Report: TAB REPORT
Function: Test, Adjust, & Balance
Date: 11/22/2024
Completed By: National TAB

11-18-24 CAVA DURHAM, NC (SOUTHPOINT)

Project: 11-18-24 CAVA DURHAM, NC (SOUTHPOINT)

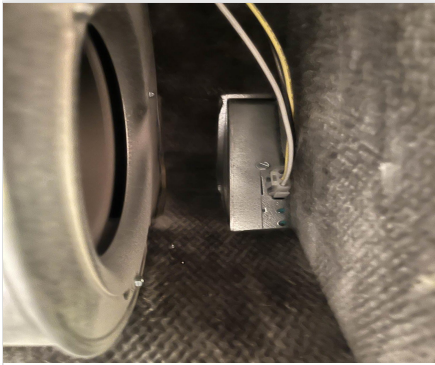
Issue Name : CEF1 & CEF2 / Speed Controllers
Description : CEF1 & CEF2 speed controllers are not installed, unable to balance fans to design cfm.
Created By : National TAB **Assigned To :** National TAB - Brianna Biggs
Status : Open
Priority : Urgent **Asset Tag :**
Originated Date : 11/22/2024 - Dale Wheeler - National TAB

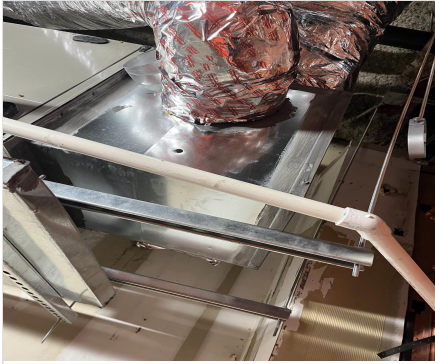
Issue Name : EF1 / Grease Cleanout Door
Description : EF1 grease cleanout door is missing wingnut.
Created By : National TAB **Assigned To :** National TAB - Dale Wheeler
Status : Open
Priority : Medium **Asset Tag :**
Originated Date : 11/22/2024 - Dale Wheeler - National TAB

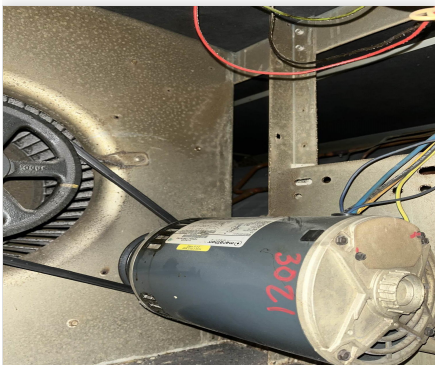
Issue Name : FCU2 / Missing Dampers
Description : FCU2 is missing dampers on SGRD6 (Hood ACPSP) unable to balance ACPSP to design cfm. Due to this issue SGRD1 through SGRD5 are low of design cfm. Unit total is within design cfm.
Created By : National TAB **Assigned To :** National TAB - Dale Wheeler
Status : Open
Priority : High **Asset Tag :**
Originated Date : 11/22/2024 - Dale Wheeler - National TAB
